**COMMENTS ON THE
GRPE DRAFT ECE COMPRESSED GASEOUS HYDROGEN (CGH₂) REGULATION
Version 10 Dated 06.11.02
(NON GRPE/ISO HARMONIZATION)**

GRPE - 003

2003-01-08

Figure X: Flex-impulse testing fixture

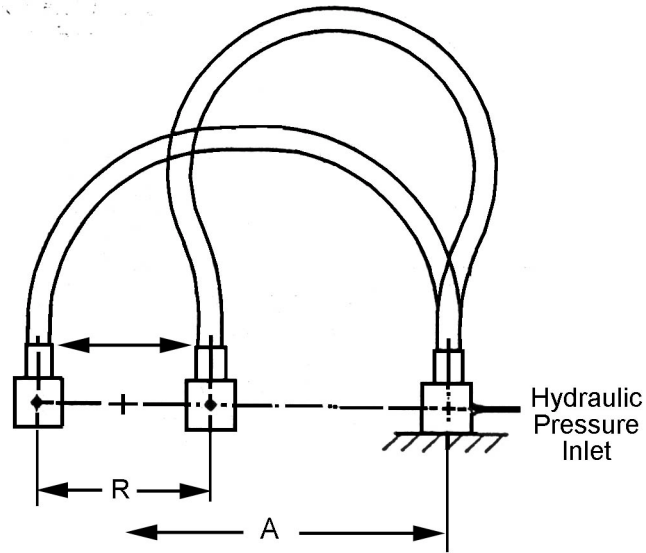
Replace B5.2.3 with a combined flex-impulse test adapted from SAE J1405.

The *Flexible Fuel Line* shall be bent in the manner depicted in Figure X and attached to a fixture in that position by the *Fittings* with which it is to be approved. One end of the *Flexible Fuel Line* shall be attached to a reciprocating manifold and the other end shall be attached to a stationary manifold connected to a hydraulic supply. The *Flexible Fuel Line* shall be pressurised quickly by means of a quick opening solenoid valve, such that one cycle consists of holding the pressure at 1.25 times the *Working Pressure* for 10 ± 1 seconds (except for *Flexible Fuel Lines* with a required material temperature of 120°C where the hold pressure shall be 1.37 times *Working Pressure*) and then reducing it to less than 0.1 times the *Working Pressure* for 5 ± 0.5 seconds. The total number of test cycles shall be equal to 2.0 times the number of *Filling Cycles* or *Duty Cycles* as appropriate to the use of the *Flexible Fuel Line* in accordance with Paragraph 2.4.6 or 2.4.7 of this Regulation as appropriate. 50% of the test cycles shall be performed at the minimum and the remaining 50% at the maximum material temperature in accordance with Paragraph 2.4.5.1 of this Regulation.

Superimposed on the hydraulic pressure cycles is a flexing cycle. The flexing rate shall be $36 \pm 2\%$ of the hydraulic pressure cycling rate. This assures that the *Flexible Fuel Line* is in a different configuration on each succeeding pressure cycle impulse. The test fixture is shown in Figure X with the distance A calculated as:

The length of the flexible part of the *Flexible Fuel Line* with its fittings attached, to be used in the following test shall be calculated as follows:

$$L = 4.142R + 3.57D$$

$$A = 1.75R + D$$

The *Flexible Fuel Line* shall not show any visible signs of damage.
